CRBRP SPECIAL STRESS AND CRITERIA CONSIDERATIONS

CRBRP ENGINEERING STUDY REPORT

ES-LPD-82-009

This report provides responses to specific NRC questions on CRBRP stress and criteria considerations.

FIGURE 3.0-7 Elastic Follow-Up Evaluation of CRBR PHTS 24-Inch Piping System Subjected to Thermal Loading

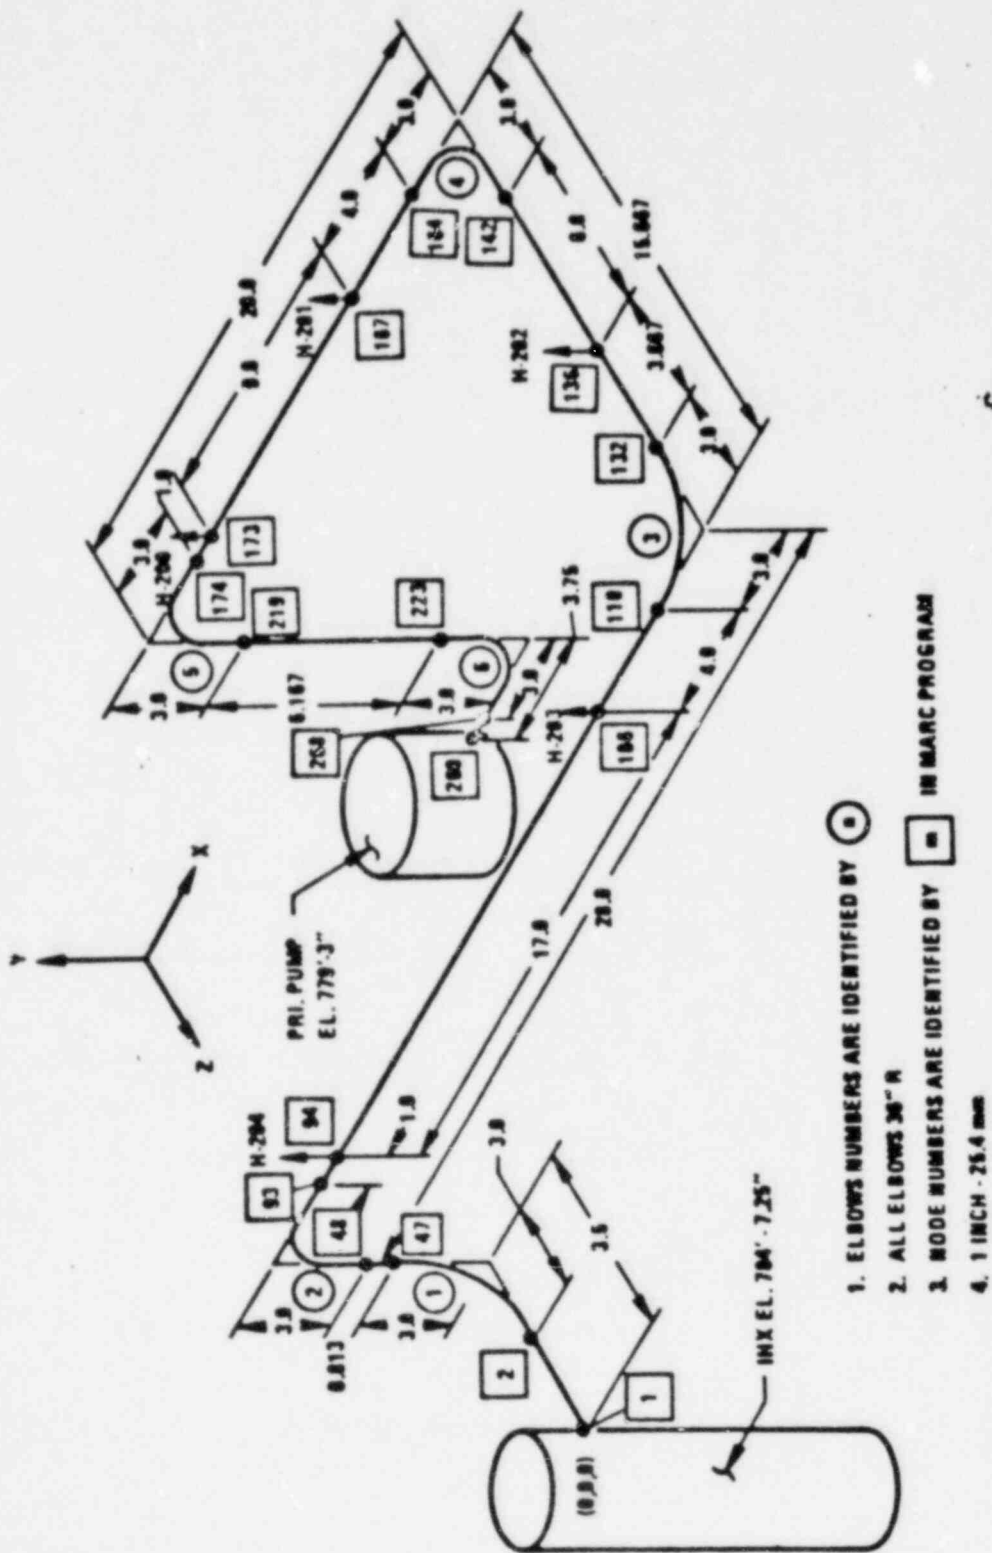
Shown in Figure 7 is a specific piping system in the CRBR hot leg. The piping is 24-inch outside diameter, half-inch thick. Because of the complex routing of the pipeline, we looked at this piping to see if there is an elastic follow-up effect due to thermal expansion loading. The straight pipes are not that highly stressed but the elbows are highly stressed, and significant plastic as well as creep strains will be accumulated in these elbows. Therefore we have examined specifically the six elbows shown in Figure 5.

This most highly stressed, 24-inch diameter hot leg piping system complied with all the inelastic criteria specified in Code Case N-47. Thus, by implication, other piping systems with similar geometry and loading conditions would also satisfy the Code criteria. In fact, this analysis philosophy is also used in structural components other than piping where the most highly stressed areas are analyzed in great detail and thus, by implication, other lower stressed areas, too, would comply with the Code criteria.

9. Rate of Increase in Local Moment Decreases With Increase in Thermal Expansion Load (Analysis I)

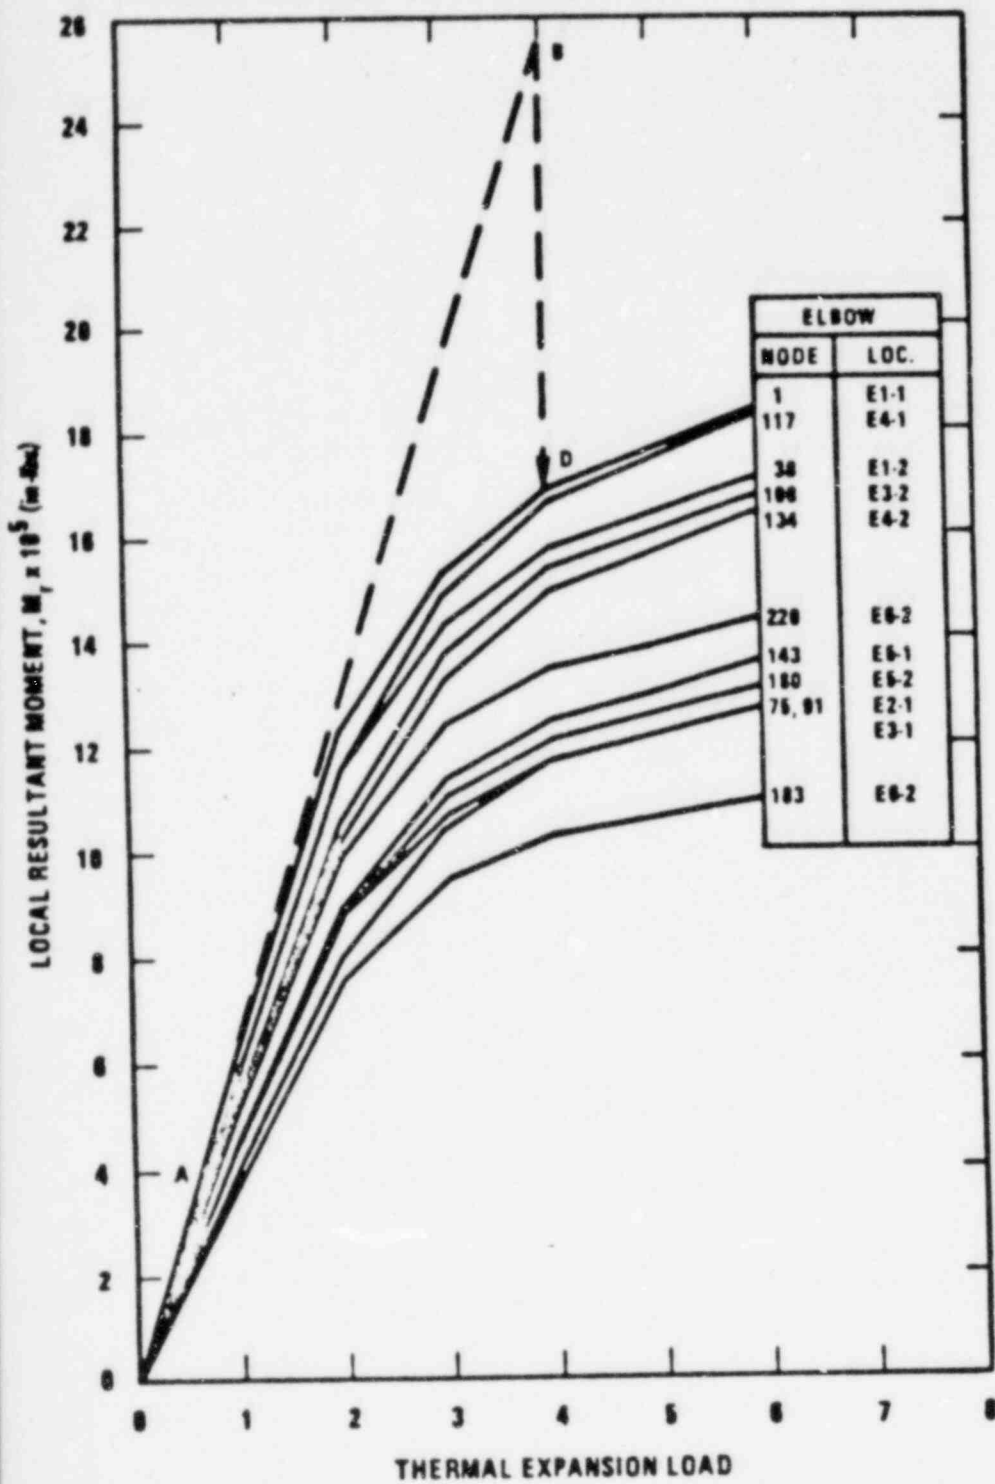
For example, what is plotted in Figure 9 is the resultant moment in each of the different elbows that I have mentioned versus the applied thermal expansion load. Thermal expansion load 1 indicates that it is an operating thermal expansion load. That means the uniform piping system temperature is increased from 70 degrees to 1015 degrees Fahrenheit operating temperature for this particular pipeline.

If an elastic analysis is performed, it will indicate that if the load is increased four times, the moment will increase four times (Point B in Figure 9). But, because of the plastic deformation capability of the elbow, the load is redistributed, and, because of that, one would find that at four times the load, we don't get four times the moment. We actually get about two-and-a-half times the moment.

The first point of Figure 9 is to show that the thermal expansion load is a load-control quantity as one would have to take if elastic follow-up were present in the piping system.

Another thing is that we don't have any criss-crossing of these resultant moment curves. This shows that, if I keep on increasing the load proportionately, each of these curves are proportionately increased. In other words, elbow loc. 6-2, the lowest curve in Figure 9, does not throw its load to elbow loc. 1-1, the most highly loaded elbow, indicating that there is no transfer of load from lower stressed elbows to the most highly loaded elbows. Thus, we don't see elastic follow-up effect.

FIGURE 3.0-10. Local Mument Relaxes With Creep Hold Time (Analysis - IA, TE Load = 1.0)

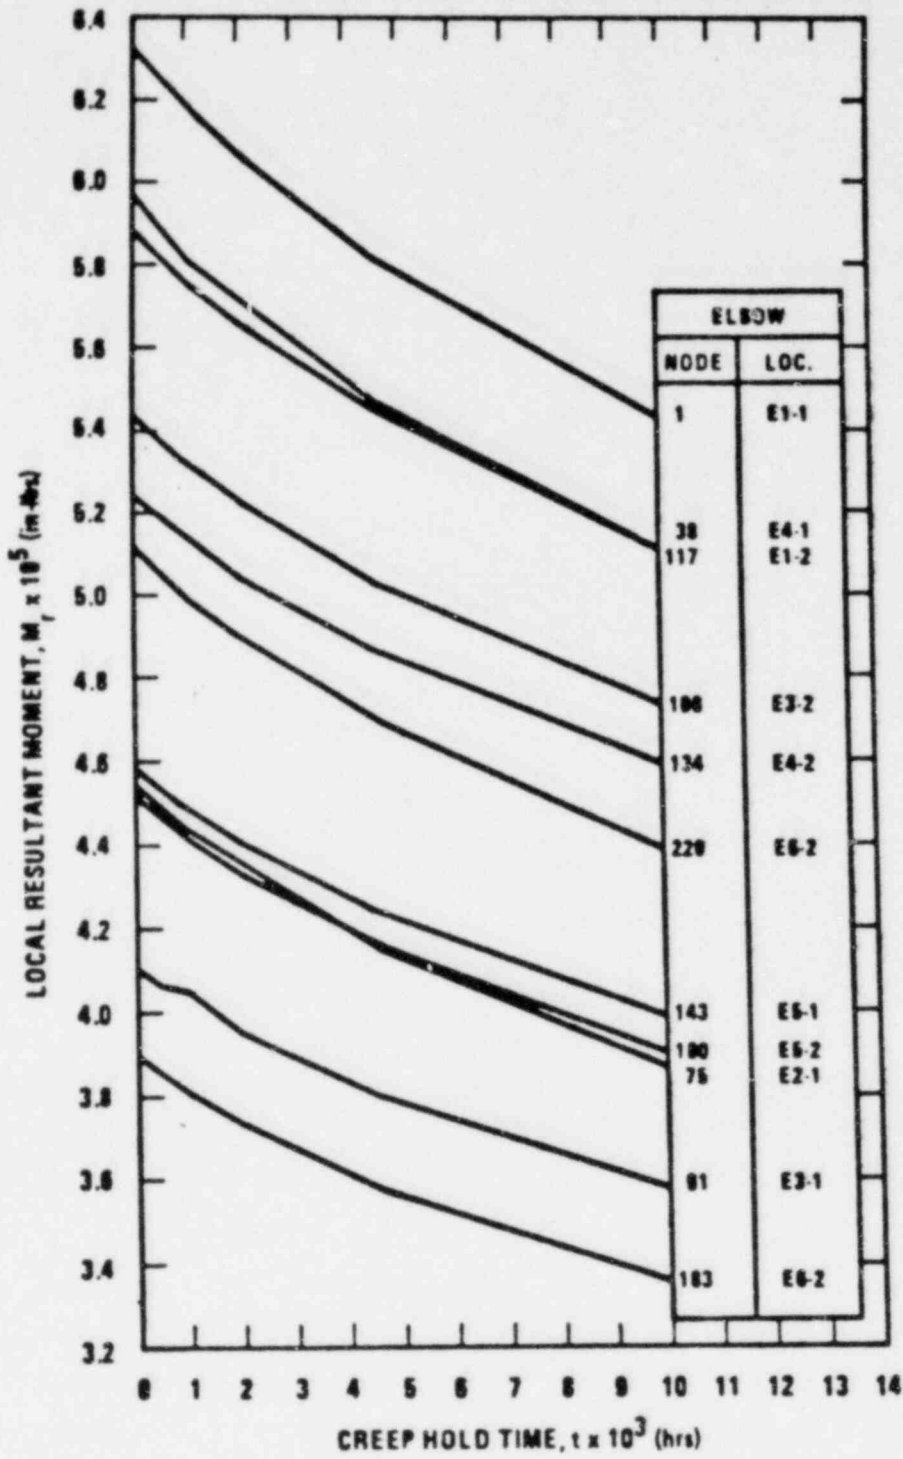
Now, if we analyze the same piping system in the creep range, we find again (in Figure 10) that the maximum stress in all these elbows -- of course, elbow 1 is the most heavily loaded elbow -- relax nearly proportionately with creep hold time. Of course, we don't have a direct comparison with uniaxial relaxation curves because in piping elbows the inelastic redistribution is much more complicated. Consequently, the resultant moments are plotted and not specific stress or strain in these elbows.

Briefly, (as shown in Figure 10) the stresses do relax at an applied thermal expansion load of one, with creep hold time of about 10,000 hours. Once again, the curves are not criss-crossing, which indicates that the thermal expansion load is proportionately carried by all the elbows in the piping system.

FIGURE 3.0-11. Local Moment Relaxes With Creep Hold Time (Analysis IB, TE Load = 4.0)

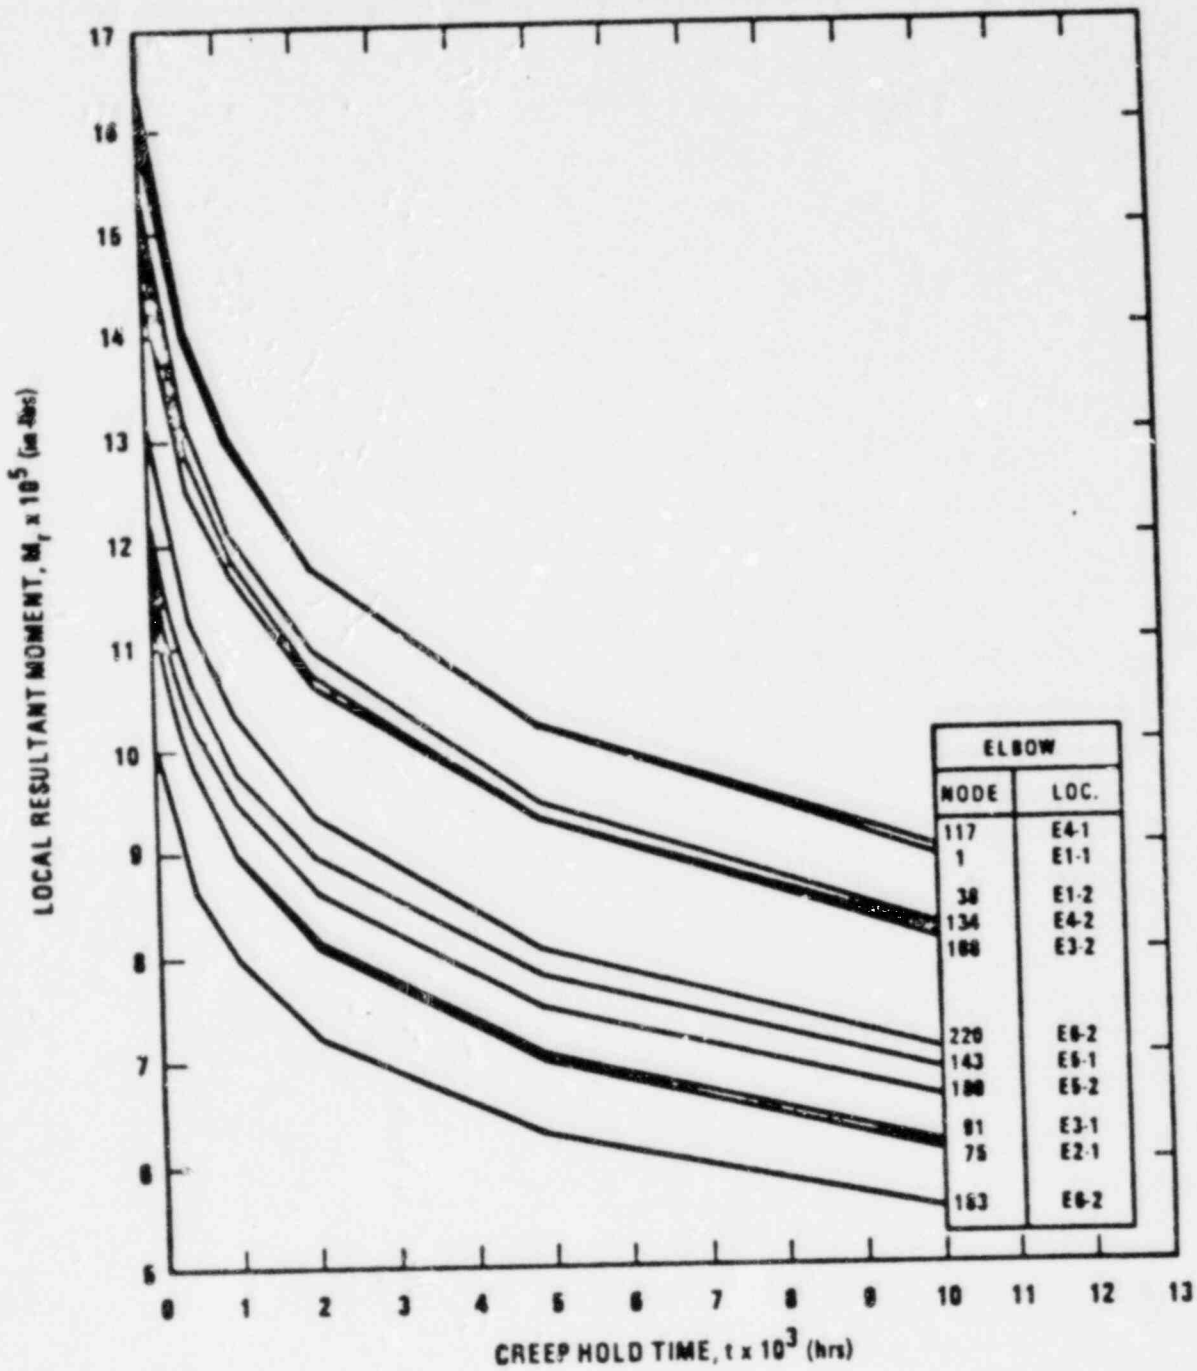
If the thermal expansion load were increased to four, the stresses would be considerably higher. If the stresses are considerably higher, with the power law relationship of creep rate depending on the n th power of stress, the stresses would relax rather rapidly. This is seen in Figure 11.

FIGURE 3.0-12. Average Normalized Resultant Moment Decreases With Increased Flexibility in One or More Elbows in Piping System

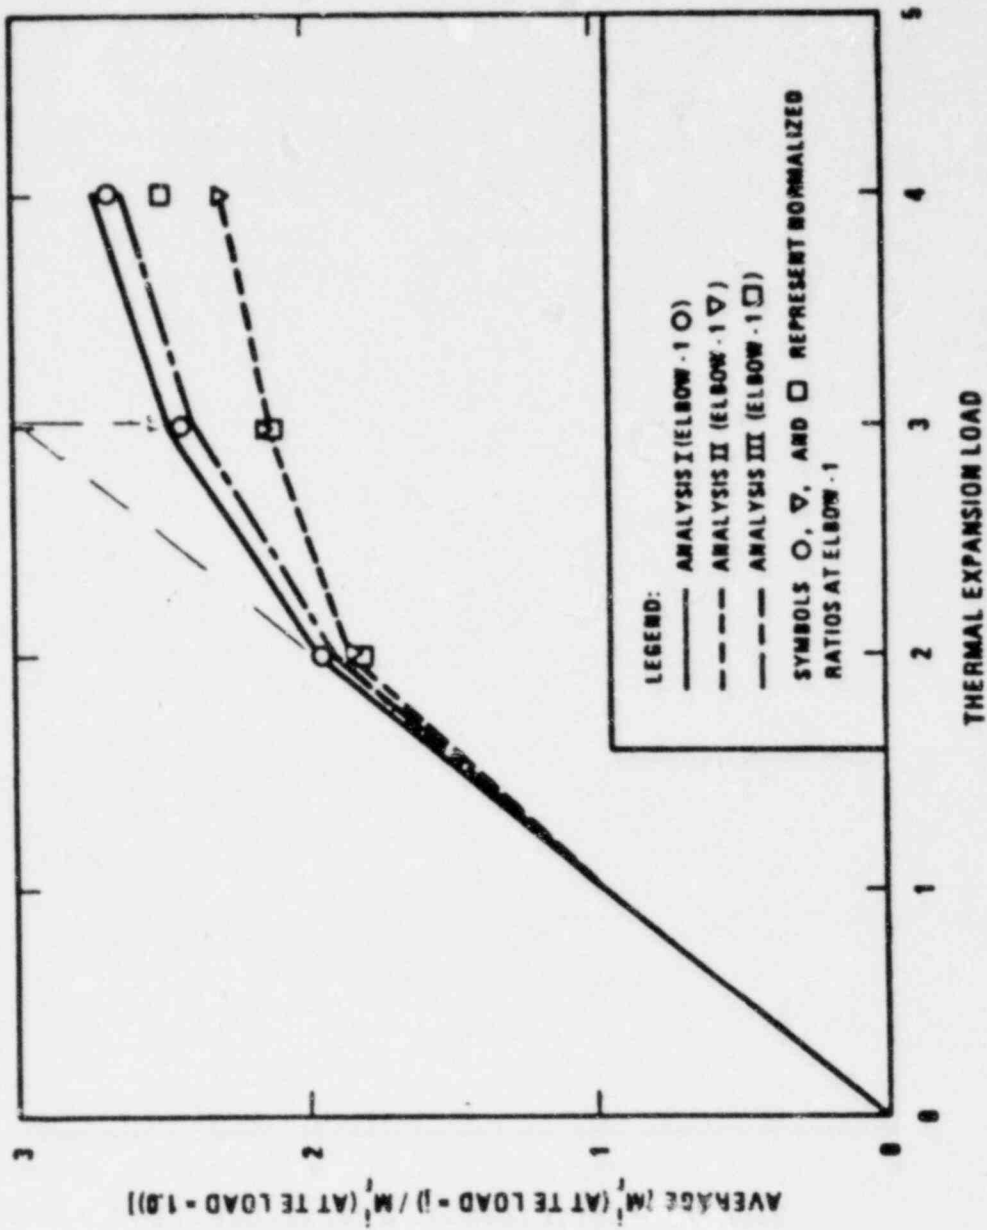
Figure 12 shows normalized resultant moments plotted against thermal expansion load. The solid line represents all the elbows of equal strength. If we make only one elbow 20 percent weaker than the rest of the elbows (Analysis III), the moment and the thermal expansion load relationship is as shown by the dot-dash line in Figure 12.

If all the other elbows are weaker and elbow-1 stays at the same standard strength, I find that the moment rotation curve drops even further, as shown by the dotted line in Figure 12.

FIGURE 3.0-13. Effective Plastic Strain Increases Linearly With Increase in TE Load Beyond 1.5 (Analysis II)

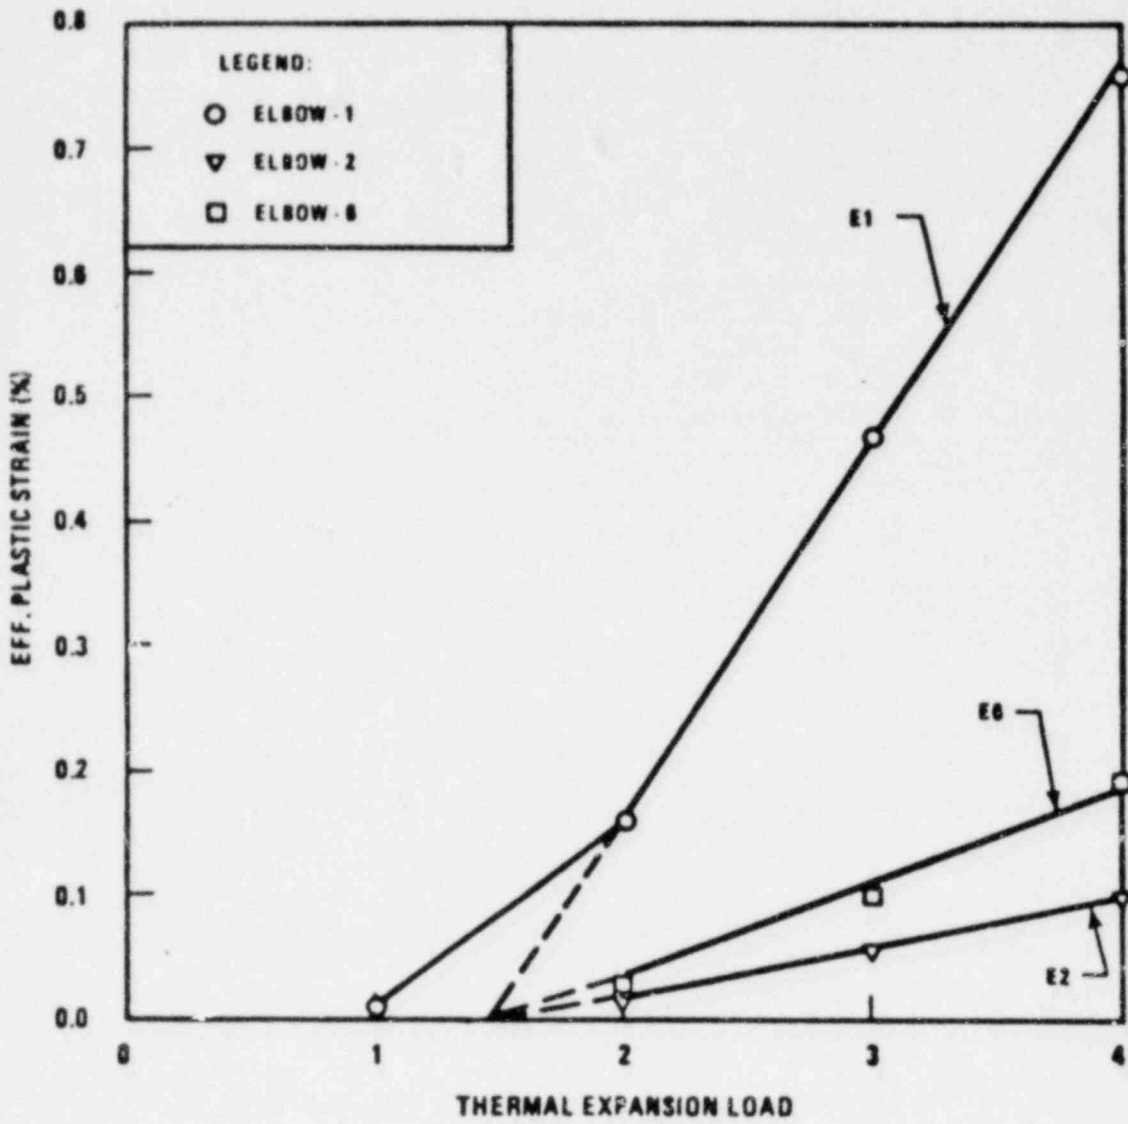
To carry this a little further, consider the strains from only one analysis (Analysis III elbow-1 20% weaker than the rest), because others are very similar. Figure 14 represents Analysis III, plotting the effective plastic strain on the vertical axis and the thermal expansion load on the horizontal axis. If elastic follow-up were present then I would, from some portion in the piping, expect elastic strains from lightly loaded elbows will reduce and transfer into the weakest and most highly loaded elbow-1. In this analysis, the first elbow is weak, so we can see if we do or do not obtain strain concentration in that elbow. These are only plastic strains in Figure 13.

Initial loading yields elbow-1 which is the weak elbow. But because of its strain-hardening capacity, it is strain-hardened, the thermal expansion load is redistributed and carried by other elbows. Then the other elbows start yielding. But, in fact, one of the elbows (elbow-5, not plotted in Figure 13) is still very much elastic; so, if we really had an elastic follow-up situation, we would have found that the lower stressed elbows, which are rather lightly loaded, would start transferring the load to the most highly-loaded elbow-1. That is not the case. The plastic strains, after thermal expansion load of 2, increase nearly proportionately with the increase in thermal expansion load.

Another way to look at the same thing is to say that if the plastic strains are analyzed, they more or less meet at a certain point here (dotted lines extrapolated to the horizontal axis in Figure 13). What it really indicates is that, by increasing the thermal expansion load beyond 1.5, which is 1.5 times the operating load, the plastic strains in all the elbows more or less proportionately increase, not just in elbow-1.
